MANDATORY SERVICE BULLETIN

NUMBER: SB11-15

SUBJECT: Crew Seat Chain Plate Inspection

TITLE: Crew Seat Chain Plate Inspection Procedures
PARENT DOCUMENT: SB11-15
JASC CODE: 2510

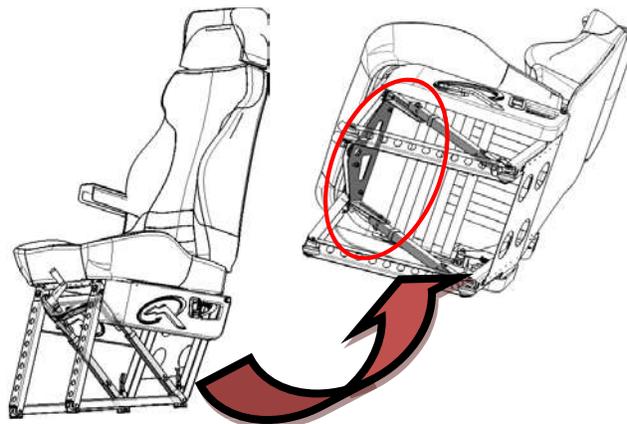
It has been found on one aircraft with over 1,000 flight hours that a crack has started to form around the nut on the crew seat chain plate, as shown on the next page. The damage is caused by users adjusting the seat height beyond its upper limit. (Adjustment arm located on the front of the crew seats between the occupant's legs.) *Quest Aircraft Company* is mandating a one-time inspection of this bracket to bring special attention to mechanics. This inspection does not change or modify the inspection requirements as defined in the *KODIAK 100 Maintenance Manual, Chapter 5 "Time Limits/Maintenance Checks."*

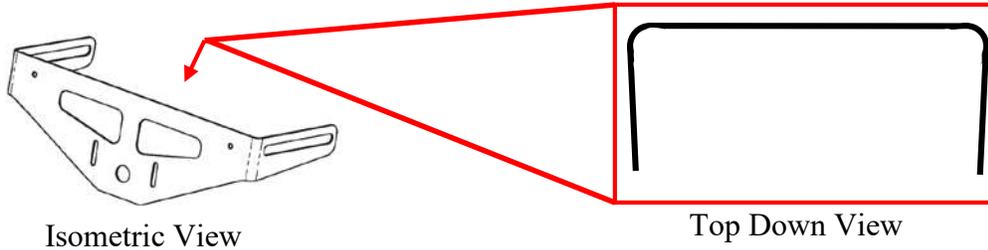
- 2.2. Cracking and other deformation/damage (See images below).

- 2.3. If brackets are incorrectly bent or cracks are found, the part(s) must be replaced. Contact Quest Aircraft Customer Service to order replacement parts.
 - 2.4. If no damage is found, continue to **Step #3**.
3. Repeat inspection procedure on the other crew seat.
4. Upon completion of all work instructions, record work completed in the appropriate *Kodiak 100 Log Books*.

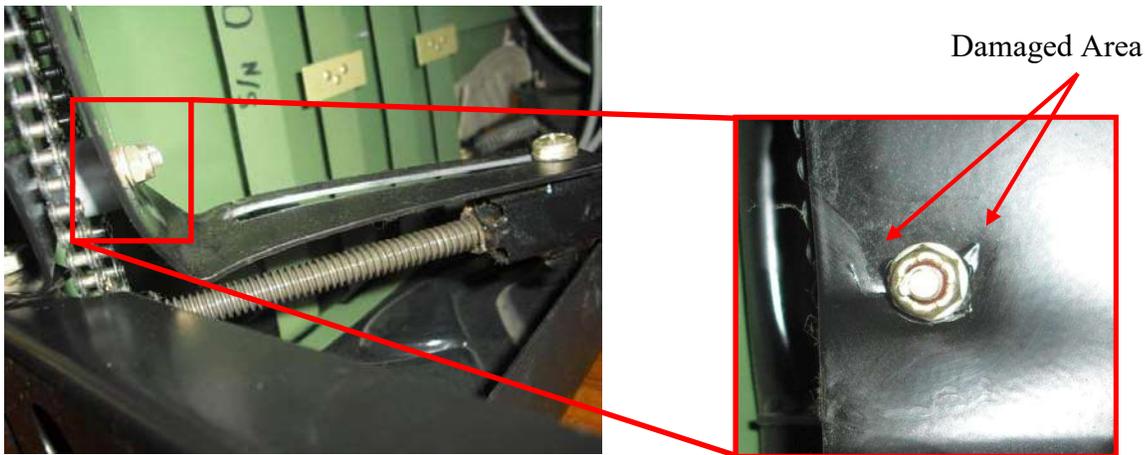
2. Inspect the Crew Seat Chain Plate (P/N 100-825-1231) for:
 - 2.1. Correct shape (See image below).
